Re: In the Matter of PORTLAND GENERAL ELECTRIC COMPANY,
2023 Clean Energy Plan and Integrated Resource Plan.
Docket No. LC 80

BEFORE THE PUBLIC UTILITY COMMISSION

In the Matter of)	
)	
PORTLAND GENERAL ELECTRIC)	OPENING COMMENTS OF THE
COMPANY,)	ALLIANCE OF WESTERN ENERGY
)	CONSUMERS
)	
2023 Integrated Resource Plan/Clean Energy)	
Plan.)	
_____)

Figure 181. Total (retail + wholesale) GHG emissions under a linear reduction glidepath (Reference Case)⁵⁵⁵

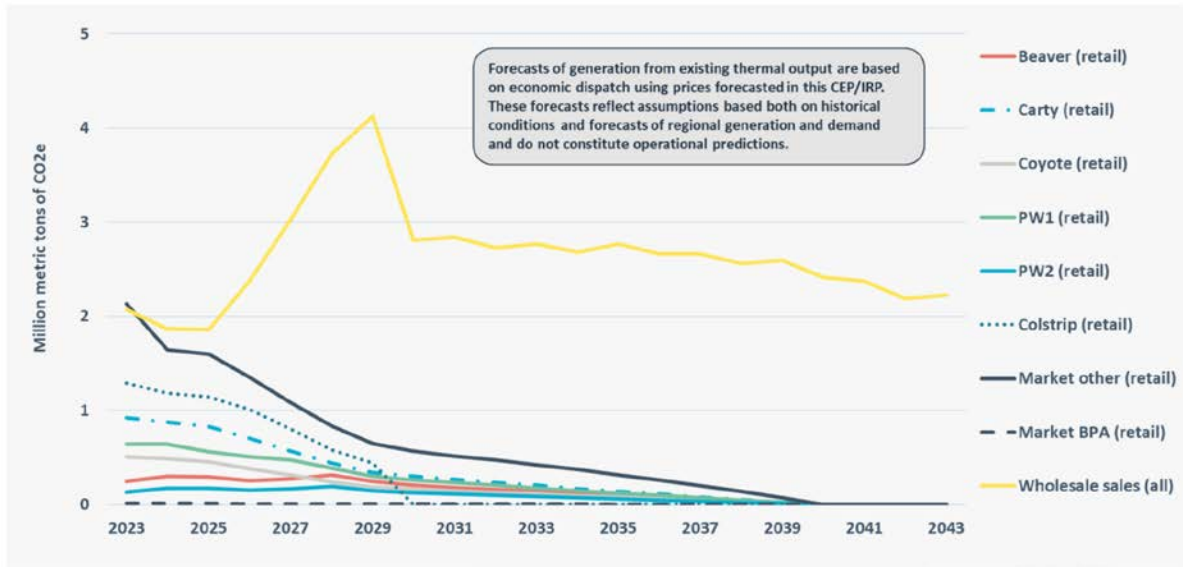
In addition to inappropriately treating market prices as fixed, PGE models increasingly large sales of emitting resources to shed greenhouse gas responsibility, which leads to unrealistic assumptions of market prices in the region. The figure below illustrates PGE emissions by source. Note that from 2023 to 2029 emissions from wholesale sales doubles from 2 million tons to 4 million tons and emissions from market purchases decline by 1.5 million tons. This

represents a massive increase in the availability of energy on regional markets. The combined impact is an injection of 885 MWa into the market.

It is unreasonable for PGE to expect Pacific Northwest markets to absorb this much emitting energy. PGE is anticipating reducing market purchases to avoid carbon burden. Yet PGE appears not to anticipate that other market participants will be making similar plans, despite the fact that many are subject to the same or similar laws. This means that, simultaneous to PGE’s planned injection of energy, there will be a substantial decrease in the demand for carbon emitting energy. Despite these market dynamics, PGE does not anticipate material declines in the value of emitting generation, which runs counter to principles of energy markets. The figure below shows that PGE finds the value of energy from a combined cycle combustion turbine (“CCCT”) to be increasing between 2023 and 2043.

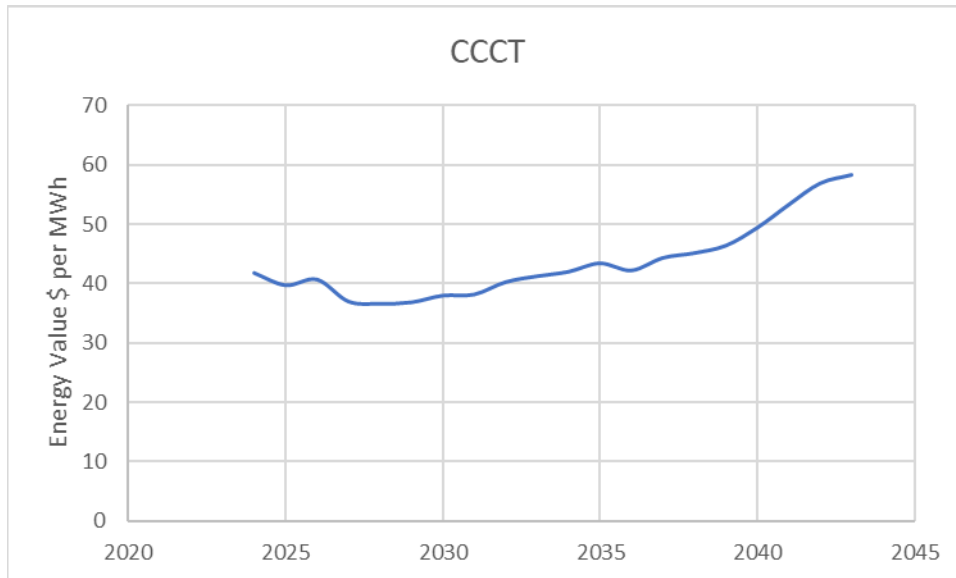
PGE’s energy values for solar and wind also increase over time despite expected increased penetration of these resources. PGE models increasing amounts of solar and wind generation. Because these resources have relatively low contributions to peak capacity needs, PGE must over-build these resources to achieve its summer and winter capacity needs. And because the resources are over-built to meet capacity needs, PGE will become increasingly energy surplus. PGE intends to market its excess non-emitting energy as well. It is reasonable to expect that many Pacific Northwest utilities will also be acquiring wind and solar resources and will have similar needs to market excess energy. The result of this would be that energy value of variable energy resources should decrease over time. However, the inputs used in PGE’s ROSE-E model show energy values from these resources increasing over time.²

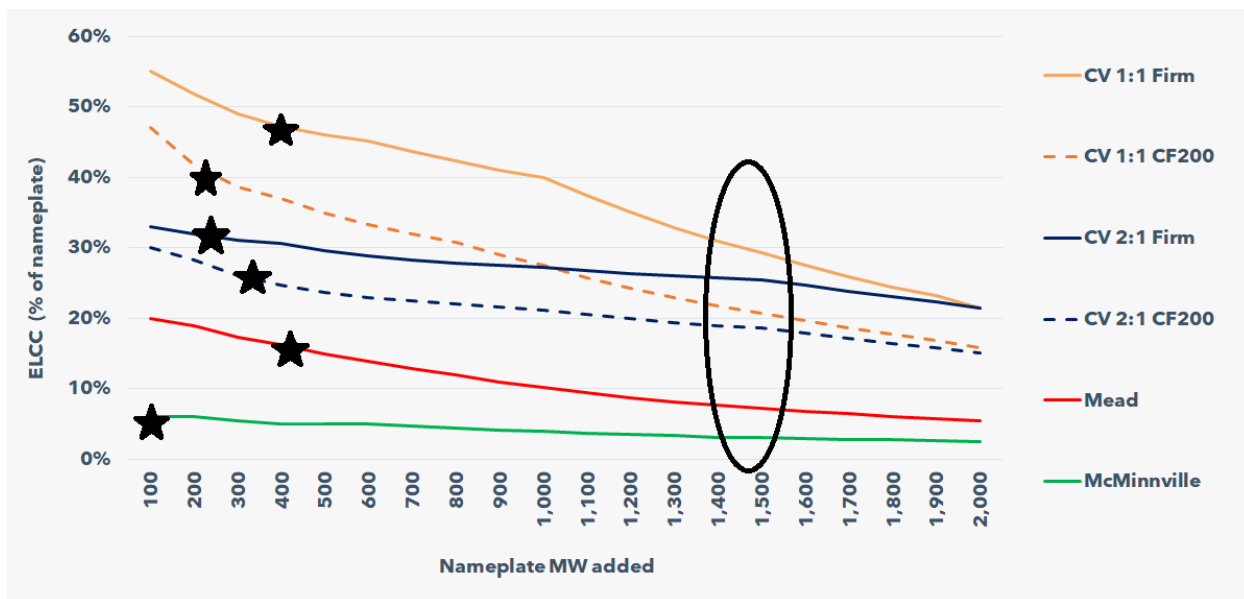
In 2030 the portfolio includes a variety of solar resources, each with nameplate capacity less than 400. However, the total amount of solar selected is 1,460 MW. The figure below illustrates the ELCC for these resources. The amounts selected in 2030 are flagged with stars, while the combined amounts are circled.

Note that the circled ELCC levels have an ELCC 30 to 50 percent less than the modeled ELCC. PGE’s preferred portfolio is capacity deficient because it over-estimates the capacity contribution of resources. This over-estimation occurs because PGE separately evaluates the ELCC of very similar resources instead of accounting for the full amount of their planned acquisition, which reduces the combined ELCC of all similar resources.
